Senator Joe Questions

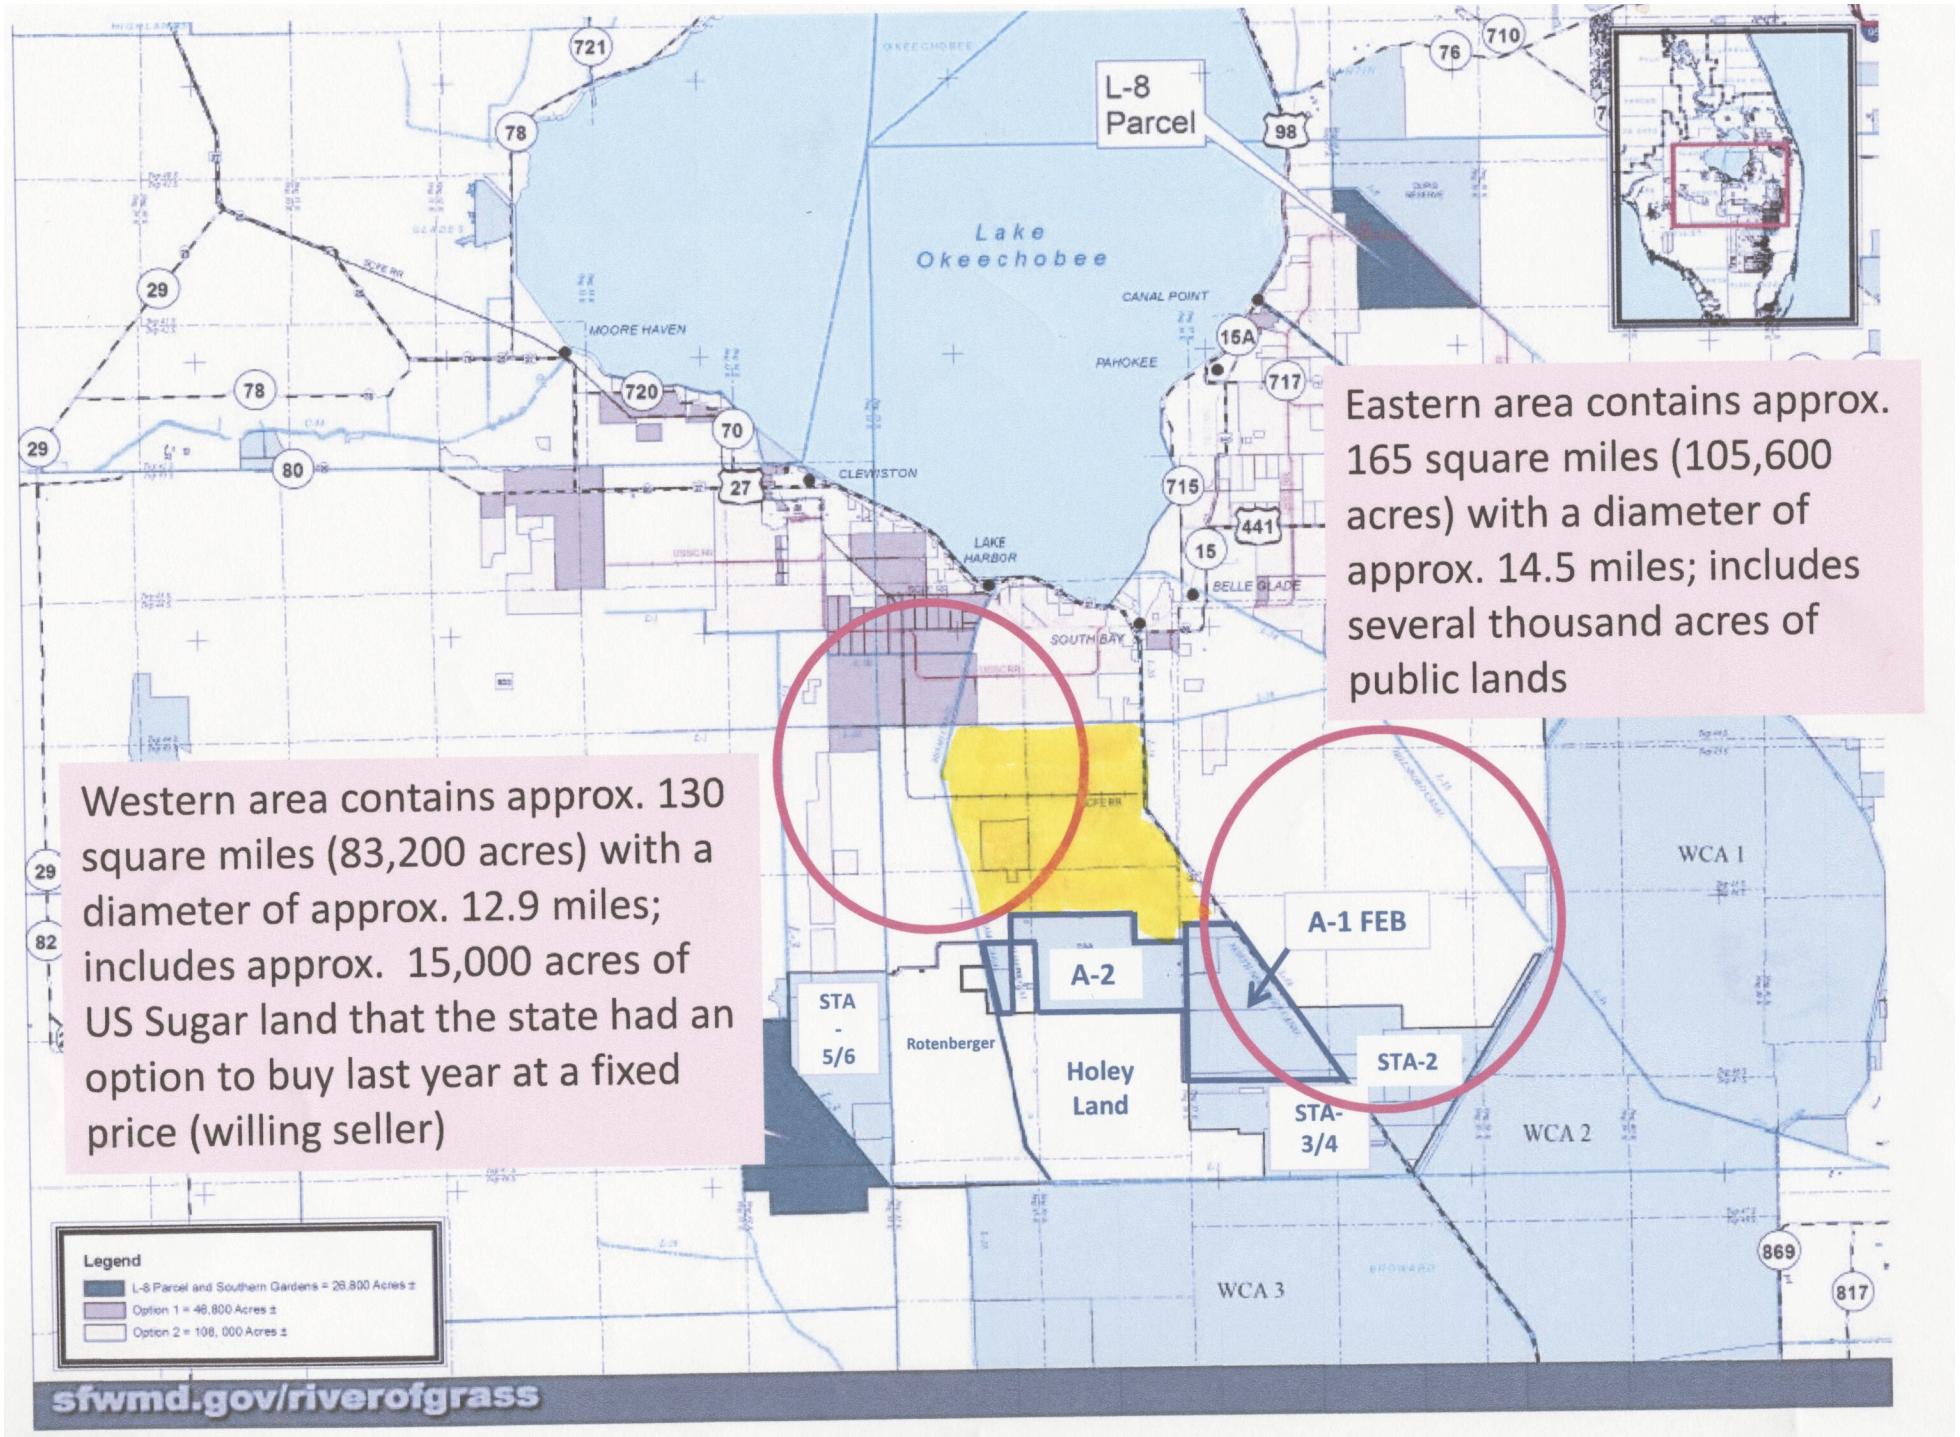
Why those two locations?

The better one to the west seems to lead to, and may conflict, with the Western Everglades Plan (WERP) and seems to lead to the Tribe's land. Is the plan is to use a greatly expanded Miami Canal to move water in and out?

The one to the east seems to move water further away from where it is needed (south and southwest) and would be the lesser of the circled alternatives.

Absent any information you may have that I am unaware of, the area immediately between your two circles would be my recommendation for several reason. Specifically, the land would be bordered on the north by the Bolles Canal, on the east by the North New River Canal, on the west by the Miami Canal, and on the south by A1 and A2. The advantages I see are below.

- As much of the land needed for conveyance and cleaning is already in public ownership, it would require less acreage to be bought.
- It leads directly into A1, A2, STA 3/4, WCA3 Everglades Park and Florida Bay – exactly where the excess water is needed.
- It has, by far, the least land owned by US Sugar, the most troublesome partner.
- It is the land previously identified by the ACOE as cheapest and best.

Can you share any information I don't already know that make the circled areas better, or at least as attractive?
